Public Service Company of New Hampshire d/b/a Eversource Energy
Docket No. DE 20-161

Date Request Received: December 27, 2022
Data Request No. CENH 1-001

Request from: Clean Energy NH

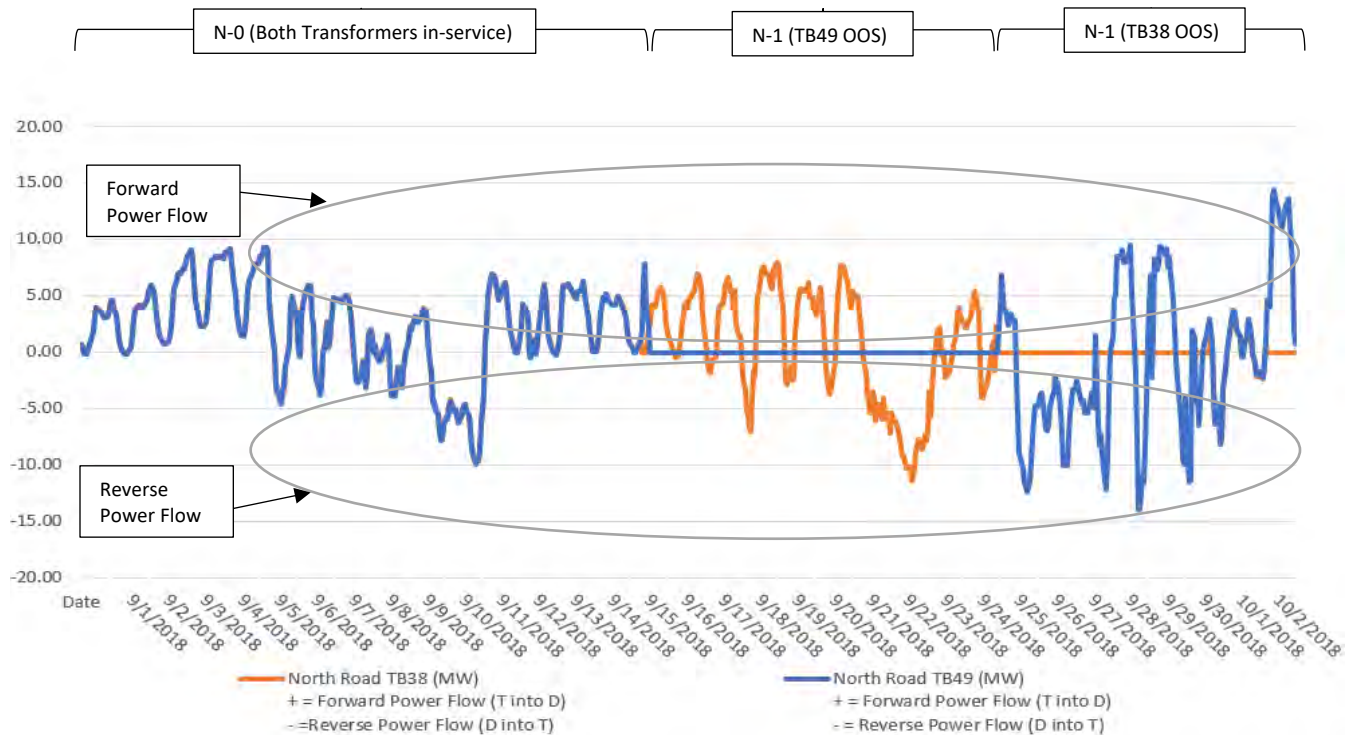
Please provide documentation concerning the outages that occurred in Eversource territory, enterprise wide, that co-occurred with low-load conditions resulting in back feeding by DERs onto transmission system.

The graph below shows the hourly MW data measured at TB49 and TB38 transformer breakers during September 2018. During the N-1 conditions (TB49 or TB38 OOS), the station experienced Reverse Power Flow (RPF) of up to 14 MW during low-load and high-generation periods.
